Index 102-661 Bicycle Facility Closures

COMMENTS AND RESPONSES

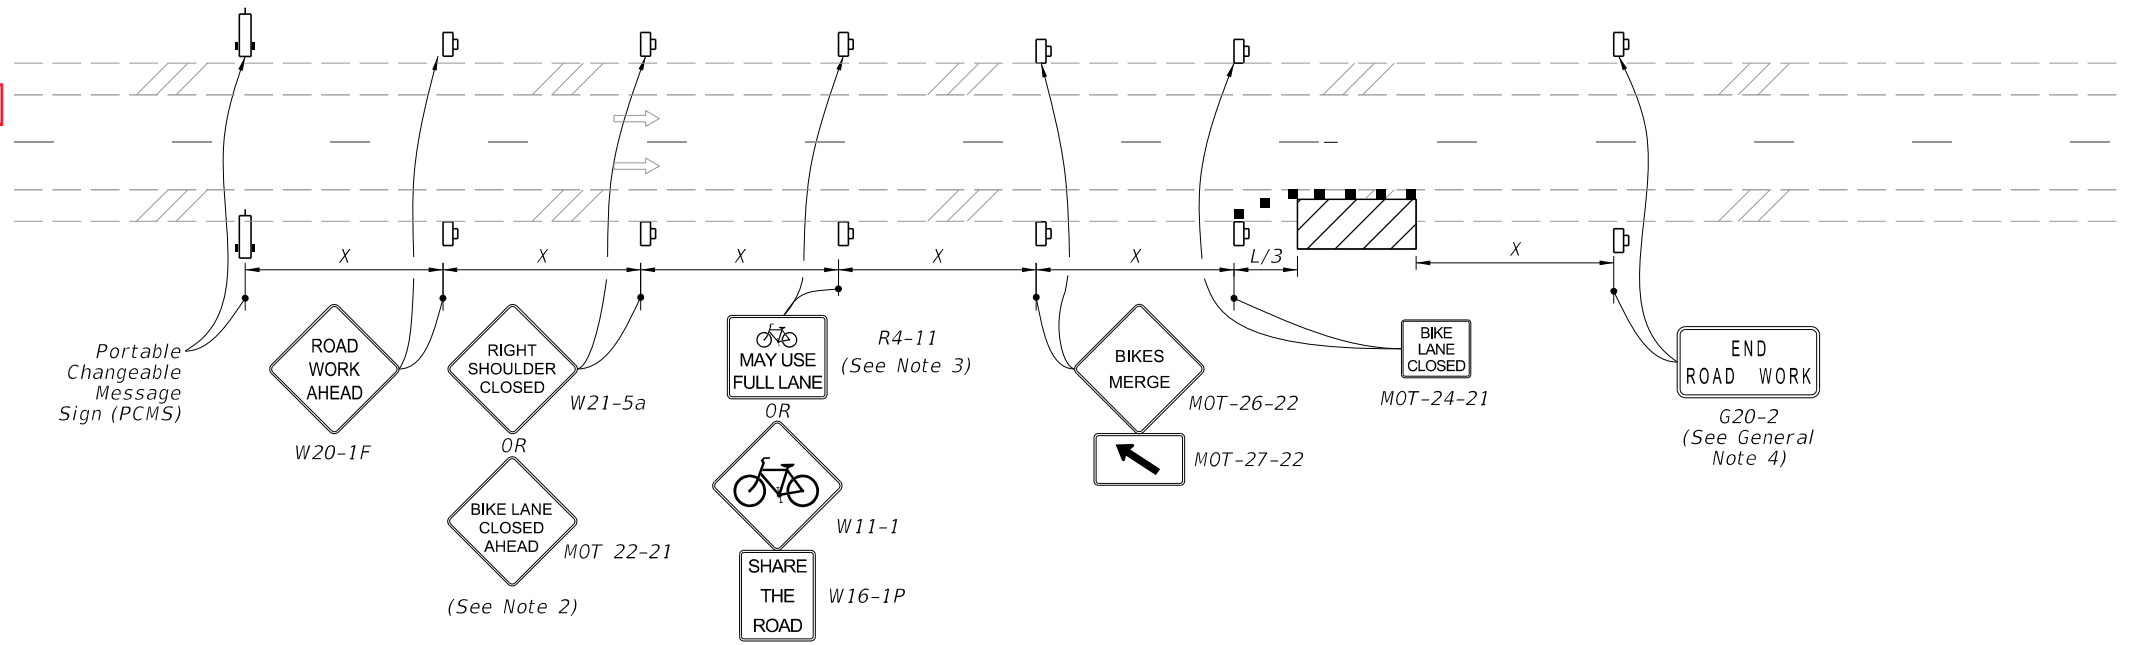
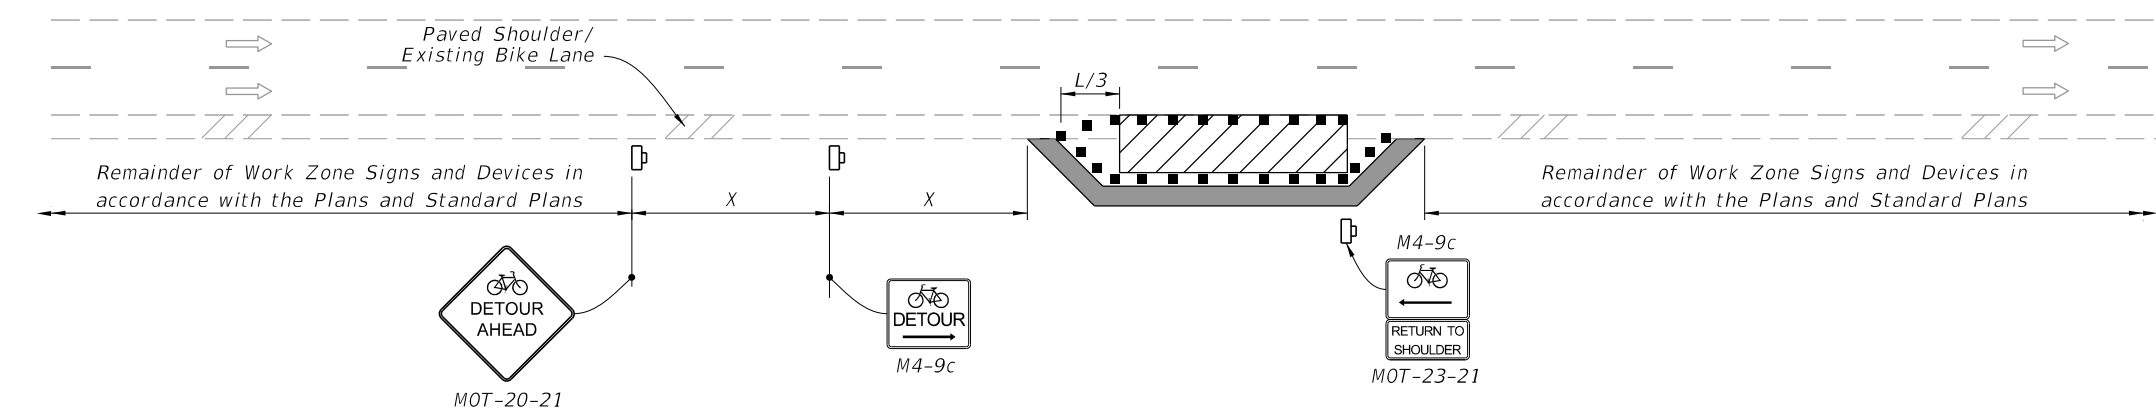
COMMENT: Sheet 2 of 2, Typical PCMS Display should be revised for consistent word choice.

Message 1: BIKE FACILITY CLOSED -> BICYCLE FACILITY CLOSED

Message 2: BICYCLES ON ROAD -> BICYCLES IN ROAD

COMMENT: It is unclear how to reconcile the bicycle facility shift on Index 102-661 Sheet 2 and the pedestrian diversions of Index 102-660.

Most applications of these shifts in District 4 are for roadside work such as curb and sidewalk reconstruction on urban section arterials and appear to be mutually exclusive. Therefore, designers are often forced to merge bicycle traffic with traffic entering a travel lane reduction, or creating their own custom design that does not comply with a standard plan. An option that reconciles 102-660 and 102-661 in ROW-restricted urban environments would be extremely useful.

COMMENT: Standard RRR design scopes very often include ADA ramp reconstruction at intersections and stop-controlled driveways.

The 102-661 Sheet 2 an 102-660 Sheet 2 options do not depict this condition. designers often either omit the details needed to construct these locations or create various custom designs. As this is a scope of work on the vast majority of RRR projects, it would be extremely helpful to show the location of bicycle and ped shifts when performing concrete demolition and pours at ADA ramps.

COMMENT: Sheet 2 of 2: NOTE No. 2: Replace MOT 22-21 w/ W20-5b. Please verify.

RESPONSE: Agreed.

CHANGE MADE TO INDEX: Index updated to be consistent.

RESPONSE: Good catch. We will update the note to reflect the sign designation change.

CHANGE MADE TO INDEX: Note updated to W20-5b.
